UNITED STATES PATENT AND TRADEMARK OFFICE

APPLICATION NO.	FILIT	NG DATE	FIRST NAMED INVENTOR	ATTORNEY DOCKET NO.	CONFIRMATION NO.	
09/909,557	07/20/2001		Jean M. Beaupre	END-778	8228	
27777	7590 02/11/2004			EXAMINER		
PHILIP S. J		. •	DAVIS, DANIEL J			
JOHNSON & ONE JOHNS		N NSON PLAZA	ART UNIT	PAPER NUMBER		
NEW BRUN	ISWICK, N	J 08933-7003	3731	K		
				DATE MAILED: 02/11/2004	. 12

DETAILED ACTION

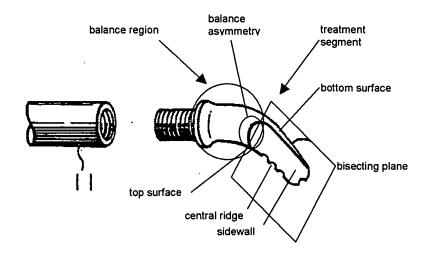
Claims 21-27 and 30-34 are rejected under 35 U.S.C. 102(b) as being anticipated by Idemoto (EP 0 456 470). Idemoto discloses a curved ultrasonic surgical end effector (Fig. 6B) comprising a concave treatment segment defining a first length and a central ridge contiguous with and extending substantially along the first length. (A figure illustrating the corresponding elements is found on page 3). A plane located longitudinally along the treatment segment bisects the central ridge and the bottom surface of the device. The bottom is convex while the top is concave. Located on both side walls is a balance asymmetry. Because the balance asymmetries have more material toward the edges of the device and less in the middle, the asymmetries will counter torque.

Regarding claims 25-27, although Idemoto fails to disclose the balance ratio, he does disclose the necessary features including balancing features, concavity, and a ridge. Therefore, the device inherently has a balance ratio of less than 1:200.
